# PD Modification Application PRS 21-0699

**Hillsborough  
County Florida**

Development Services Department

Request Limit proposed uses, Change building footprint, access points, operating hours

TS-7

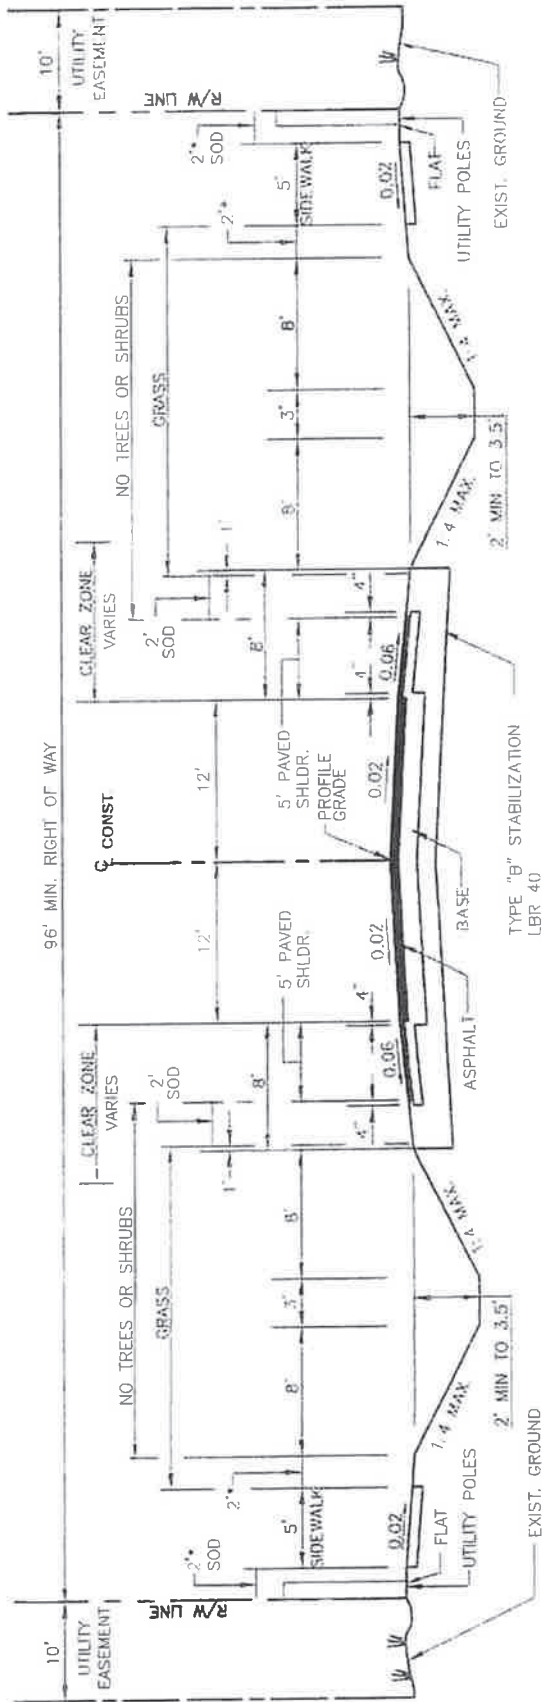
- 1) Right of Way – TS-7 has 96 feet of right of way. The existing roadway has approximately 60 to 80 feet of right of way.
- 2) Lane Width – TS-7 has 12 foot lanes. According to the latest improvement plans, the existing roadway has 11 foot lanes. According to Table 201.2.1 of the 2020 Florida Design Manual, 10 foot lanes are acceptable for Suburban (C3)/Urban General (C4) roadways with a design speed between 25 MPH and 35 MPH.
- 3) Shoulders – TS-7 has 8 foot shoulders with 5 foot paved. According to the latest improvement plans, there is a 6 foot shoulder with 5 foot paved.
- 4) Sidewalk – TS-7 has 5 foot sidewalks on both sides of the roadway. There is existing sidewalk on the west side of the roadway.

**TYPICAL SECTION**  
**4th STREET**

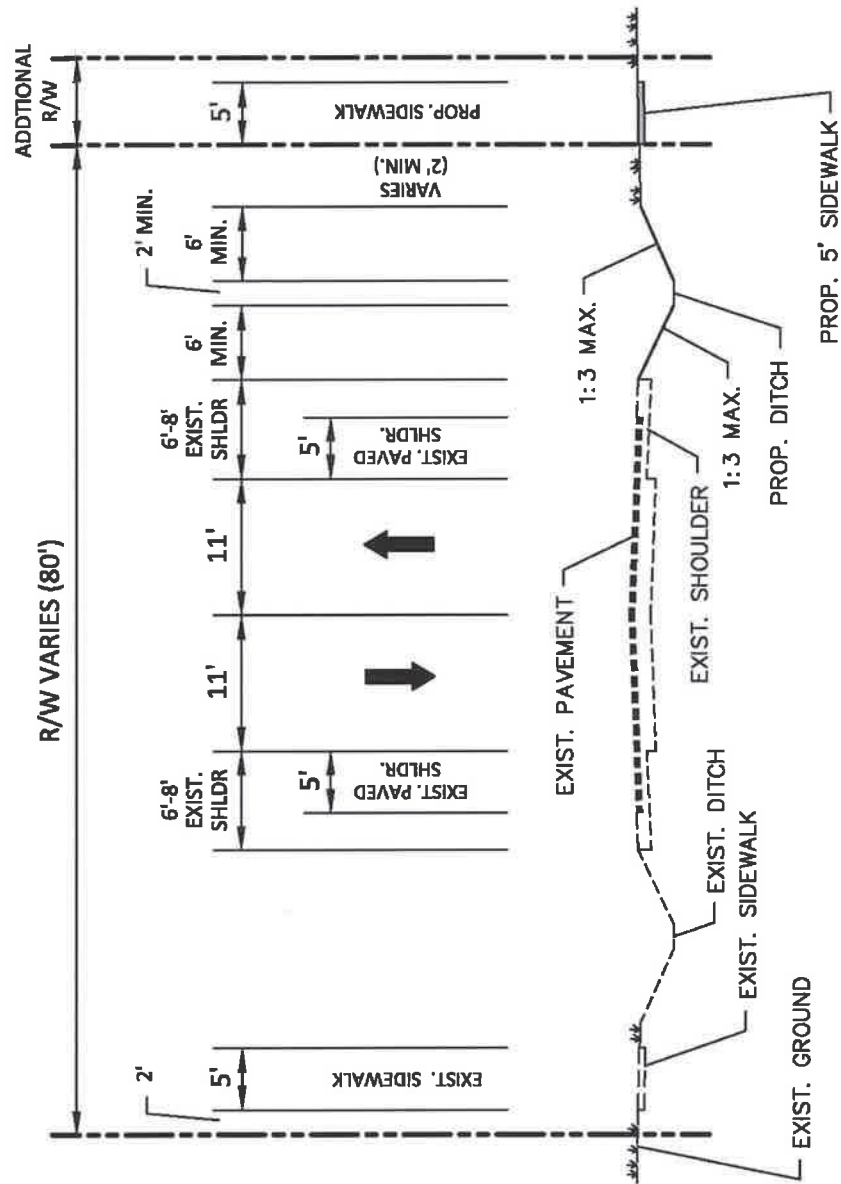
Our Design Exception request will require that we incorporate modifications to typical section TS-7 as follows:

DRAWING NO. TS-7

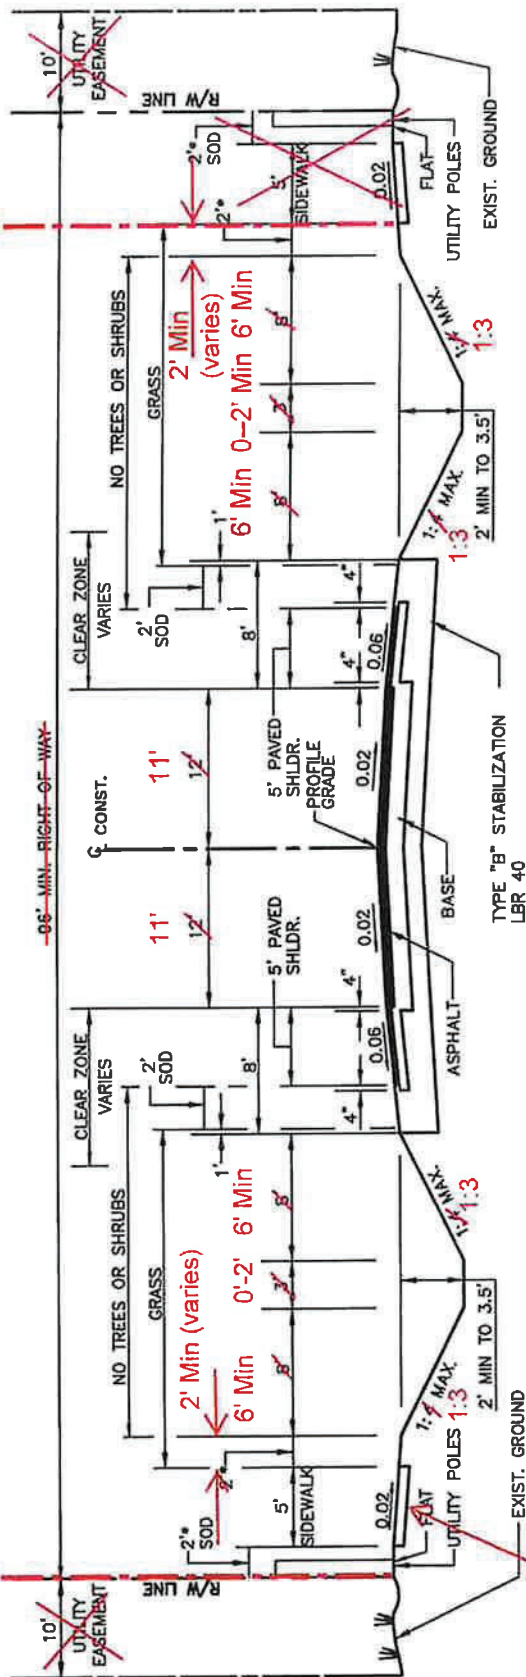
- 1) Reduce the drive lane width from 12 feet to 11 feet;
- 2) Reduce the side slopes of the roadside ditches from 1:4 to 1:3;
- 3) Reduce the ditch bottom width to 0'-2' in order to provide 6% *maximum* slope from EOP to top of ditch;
- 4) Provide a sidewalk along the West side only.
- 5) The applicant does not have the authority to dedicate a 10' utility easement within private property not belonging to the applicant, therefore an easement will not be provided on either side.

Provide sidewalk on one side for connectivity to West College Avenue

Based on the information provided by the applicant, the request is:

**LOCAL & COLLECTOR RURAL ROADS  
(2 LANE UNDIVIDED)  
TYPICAL SECTION**

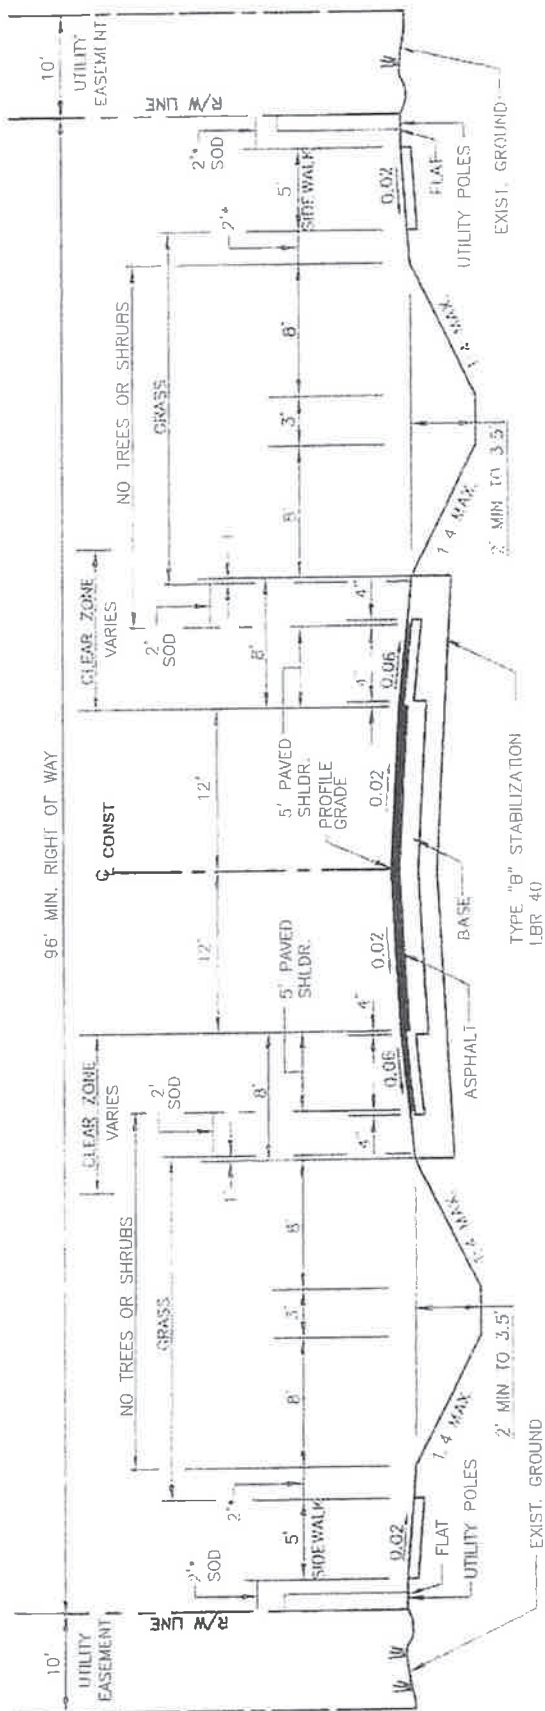
- 1) Reduce the drive lane width from 12 feet to 11 feet;
- 2) Provide a consistent 6' wide shoulder from edge of drive isle to top of ditch to include a 5' wide paved and 1' wide stabilized shoulder, in lieu of the typical shoulder section shown in TS-7;
- 3) Reduce the side slopes of the roadside ditches from 1:4 to 1:3;
- 4) Reduce the ditch bottom width to 0'-2' in order to provide 6% *maximum* slope from EOP to top of ditch;
- 5) Provide a sidewalk along the West side only.
- 6) The applicant does not have the authority to dedicate a 10' utility easement within private property not belonging to the applicant, therefore an easement will not be provided on either side.

Provide sidewalk on one side within private property for connectivity to West College Avenue. Provide sidewalk Easement

### TYPICAL SECTION

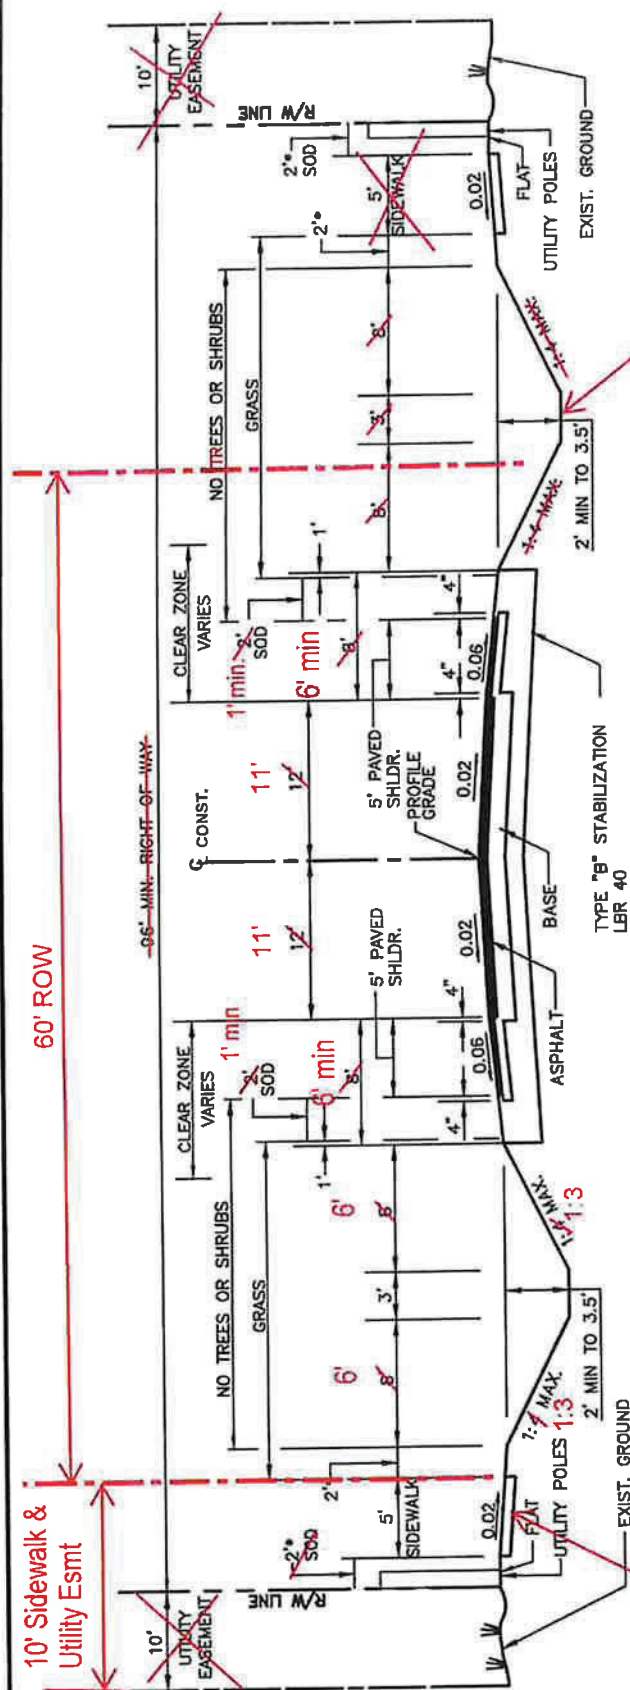
Provide sidewalk on one side for connectivity to West College Avenue

Existing Roadside  
Ditch to Remain
